Proposed amendments to approved drawings 23/00189/LBC are shown in red.

**LITTLE JERICHO
BLACKMORE**

**PROPOSED FIRST AND SECOND
FLOOR PLAN**

242.13G

First Floor Plan

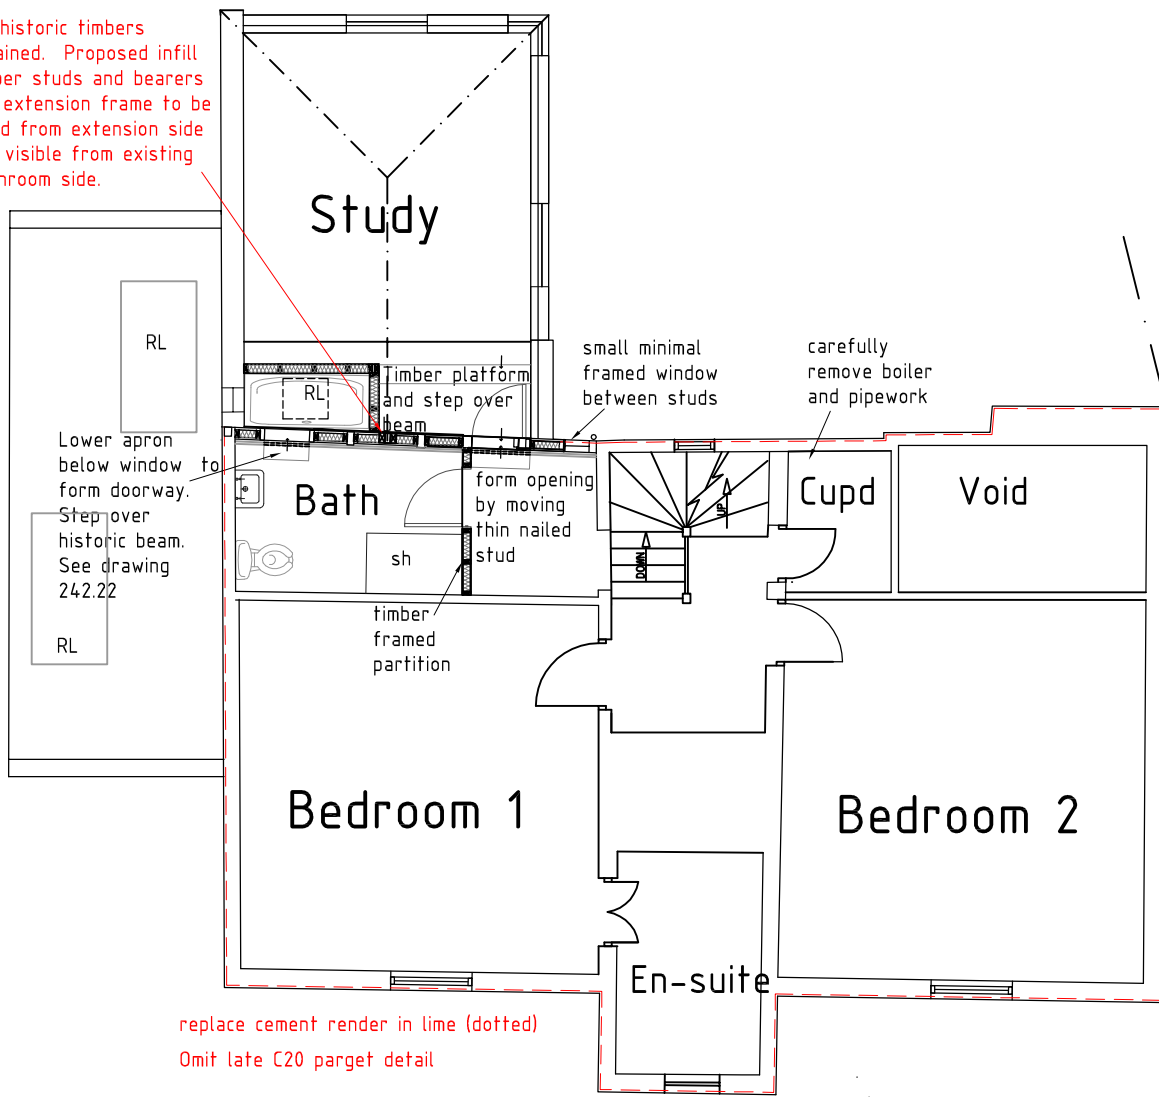
All historic timbers retained. Proposed infill timber studs and bearers for extension frame to be fixed from extension side not visible from existing Bathroom side.

Second Floor / Extension Roof Plan

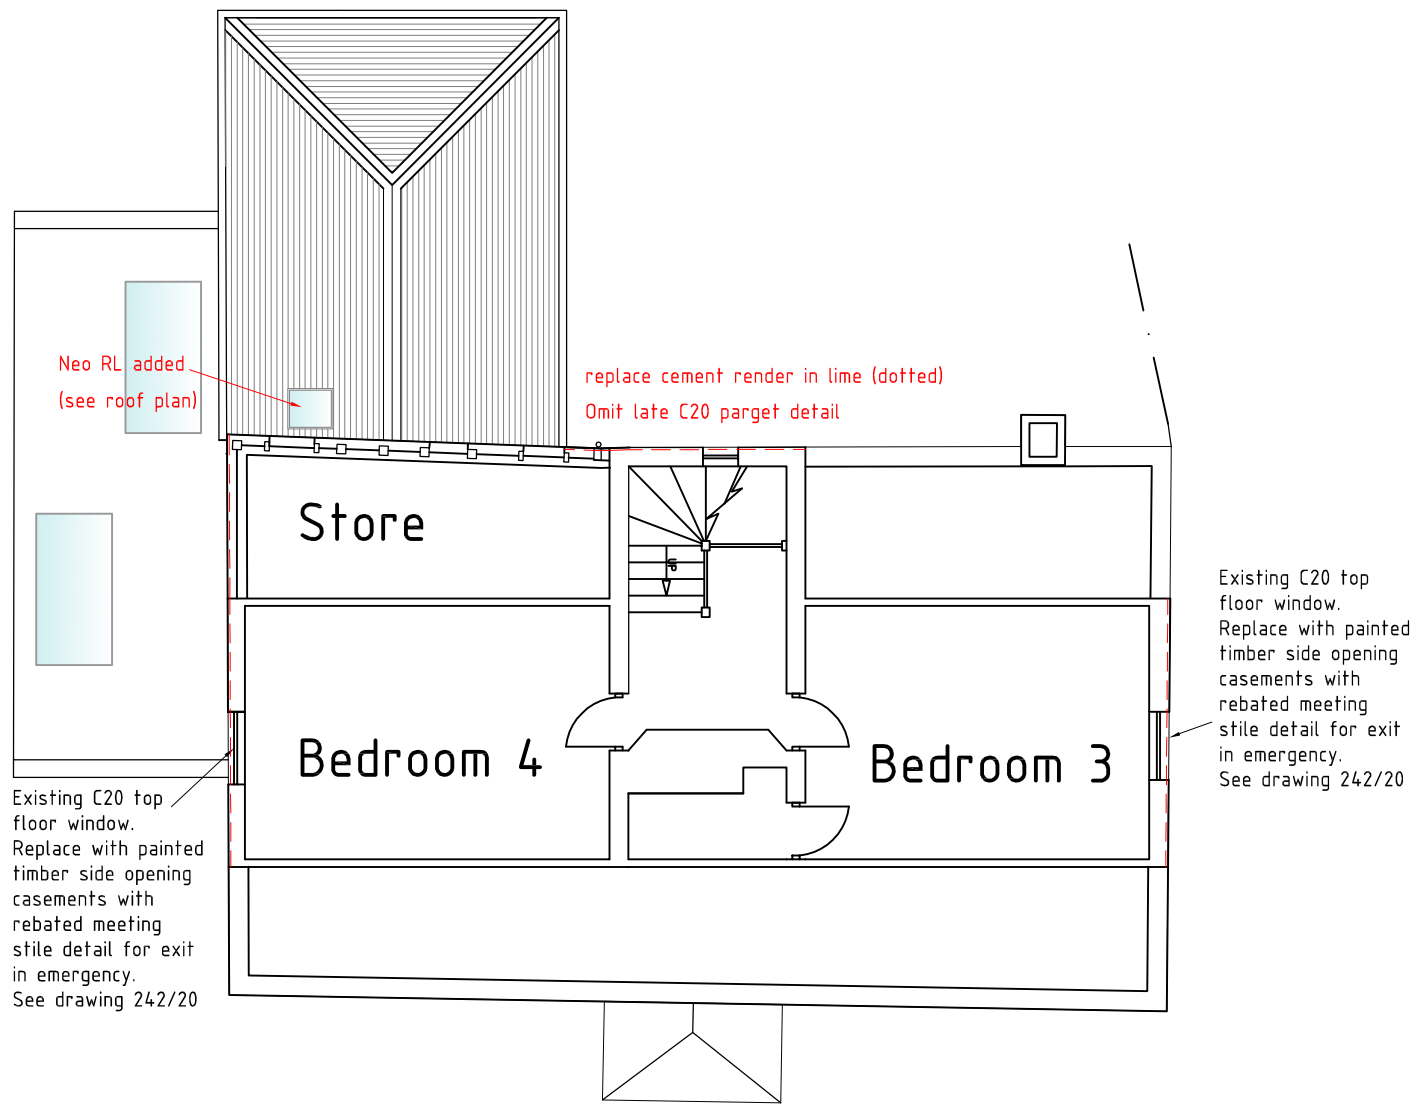
Allow to replace late C20 cement render in lime subject to agreement of render sample. Omit late C20 bottle parget panel detail to reinstate appearance to the flush appearance of the historic photograph shown in the Heritage Statement.

Allow to retain any sound historic lathes that survive and to carefully remove metal mesh.

In principle any areas retaining historic lathes are to be repaired in matching timber lathe and the metal mesh substrate is to be replaced with 15mm external quality woodwool or similar agreed breathable substrate. Allow to insulate in Steico woodfibre or similar breathable insulation batts if practical to do to a whole wall without disturbance of historic fabric and without cold bridging.

Allow to finish in Anglia Lime external lime render mix.
